Item 4.**Development Application: 1-17 Euston Road, Alexandria**

File No.: D/2017/1297

Summary

Figure 24: Long section plan with maximum building height marked in red

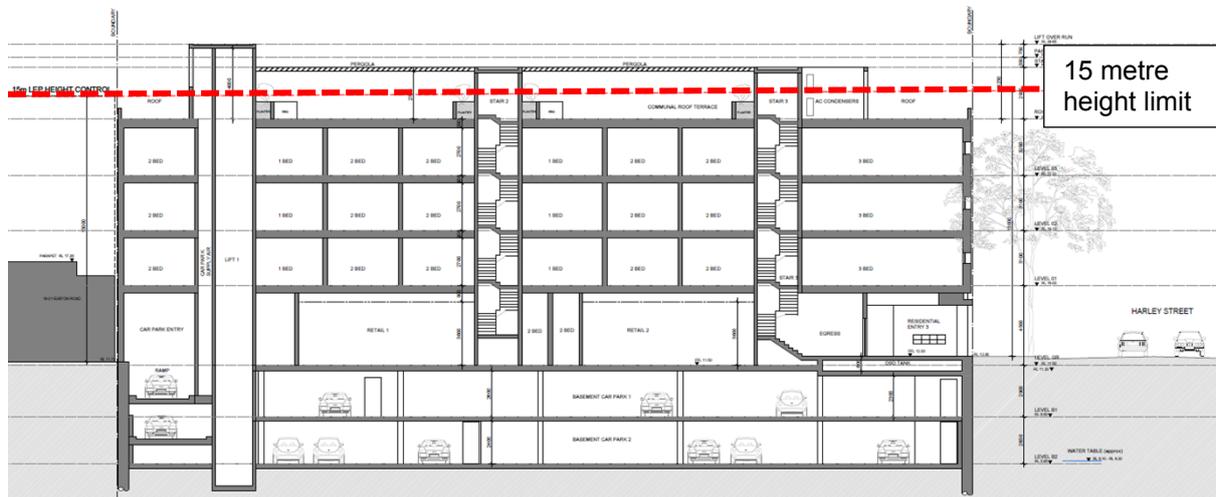
51. The proposal results in a maximum height of building of 18.25 metres. This exceeds the 15 metre height of buildings development standard specified for the site by Clause 4.3 of the SLEP 2012 by 3.25 metres or 21.7%, as indicated in the figure below.

- (a) The exceedance of the building height development standard is appropriate to the condition of the site and its context as it is limited to lift overruns, stair wells, plant, ventilation chimneys and pergolas. These permit equitable access and shade amenity to the required area of communal open space and passive natural and mechanical ventilation to the dwellings within the development.

Figure 25: Extract from the 'Second Floor Plan' drawing by Carlisle Architects indicating the extent of building separation considerations under 2F of the ADG and SP2 zoned land.

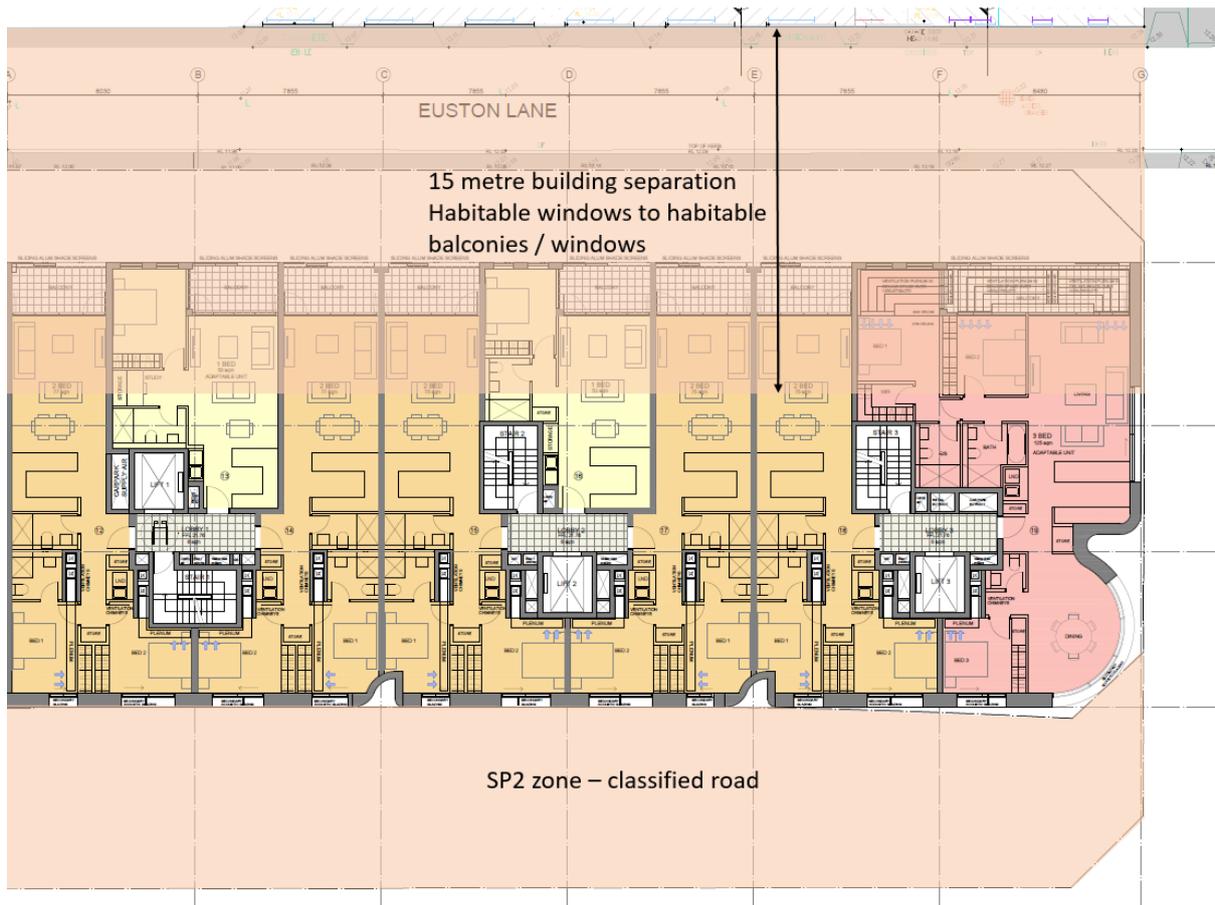
71. The separation distances of 10 metres and 13.3 metres are considered acceptable given the following:
- (a) The design of the building to Euston Lane has an appropriate form, bulk, scale and massing, subject to the recommended design modification conditions which require additional facade modulation and landscape elements;

- (e) Strict compliance with the above-mentioned building separation considerations, in conjunction with the area of land required for road widening along Euston Road, would render the site unviable for development, as indicated in the figure below.

Figure 27: Section extract from the 'Natural Ventilation System' drawing by Carlisle Architects indicating details of the proposed passive natural ventilation plenum and chimney system.

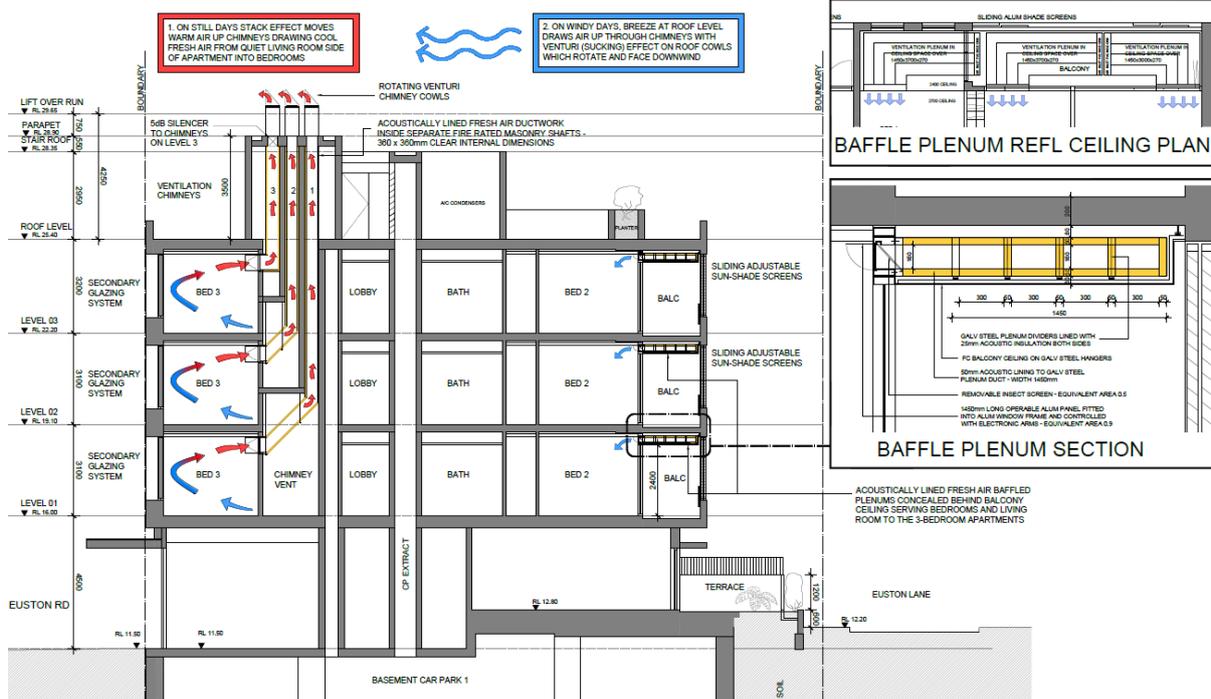
81. The amended proposal incorporates an acoustically attenuated passive natural ventilation plenum and chimney system to each noise affected dwelling (refer to the detail provided in the figures below). This system has been peer reviewed by a sustainable building consultant and is considered generally acceptable, subject to the conditions in **Attachment A** to this report.

82. The use of this type of system to ventilate the noise-affected habitable rooms within the development is supported. The proposal is considered to be capable of satisfying both the ADG requirement for all habitable rooms to be naturally ventilated and the SDCP 2012 requirements for acoustic privacy.
